Aesthetic Assessment Report for the Proposed Northland Solar Project in Lowell, Vermont

Prepared for the Town of Lowell
March 27, 2026

Figure 3: The varying quality of a Farm-Forest landscape.

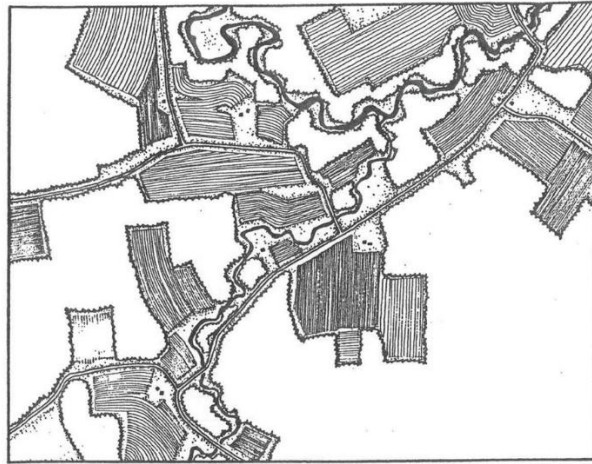
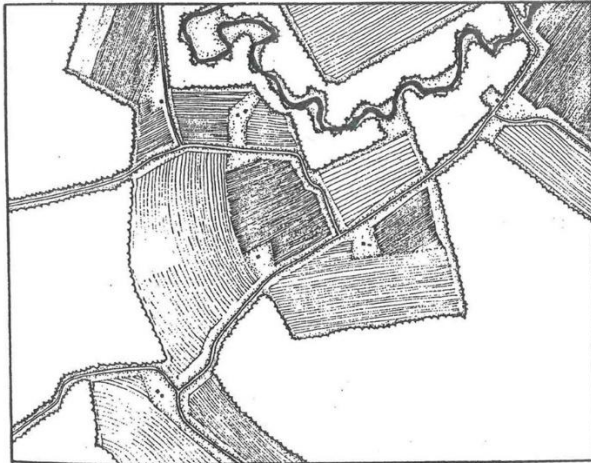
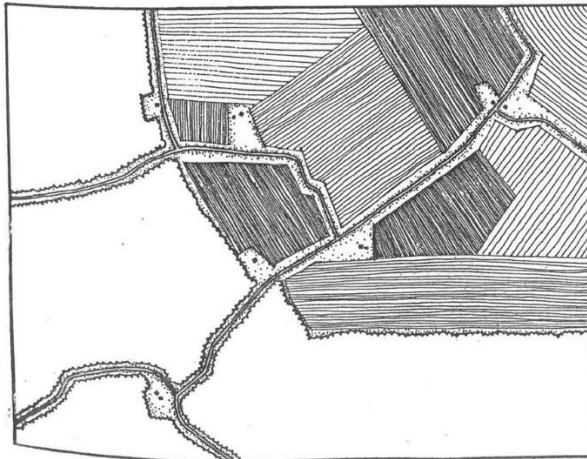
Using the matrix shown in Figure 3, one can conclude that the town of Lowell ranks as Medial to High in its quality as a Farm-Forest landscape.

Figure 4: Solar Installation Scale in Relation to Four Corners

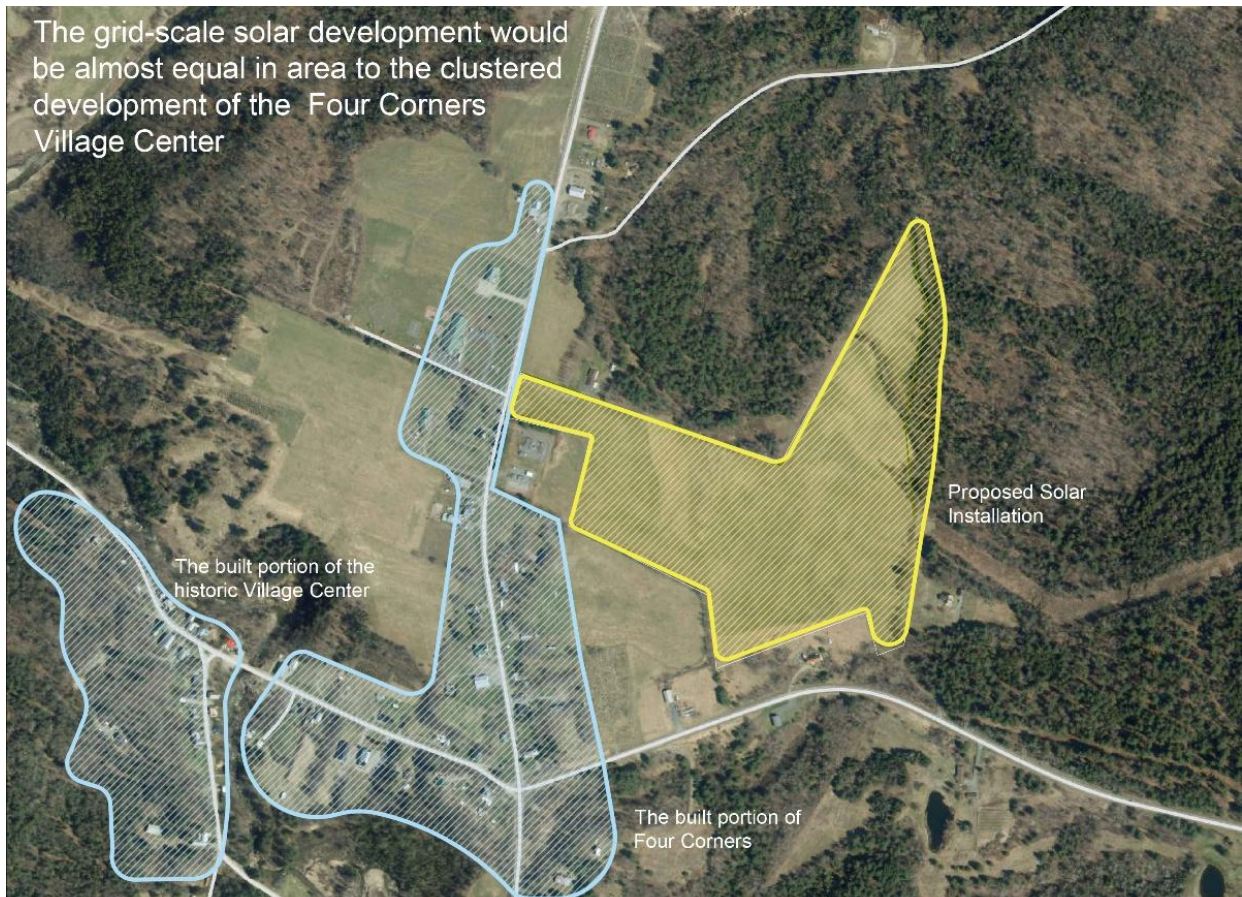
The efficiency of densely-clustered panels leaves smaller intervening openings, such that they read as a single contiguous block, resulting in an installation the size of a big box parking lot. The absolute scale of this block of panels is visually out of scale with any other development in the vicinity. It rivals the entire built village center of Lowell's Four Corners (see Figure 4).

Figure 4 illustrates the development in proportion to the adjacent Village Center. The developed land of the Four Corners area of the Village Center (roughly ½ of the complete Village Center), to which the field in question sits adjacent, measures approximately 50 acres. It is only a portion of the Four Corners Village Center mapped as part of the FLU plan, the remainder being ball fields, woodlands and other open space. The proposed solar facility, itself exhibiting structural or architectural characteristics, is directly adjacent to and essentially equal in size to the entire developed Four Corners area. This would essentially create a rival development, void of human habitation or public use, directly adjacent to the Four Corners center.
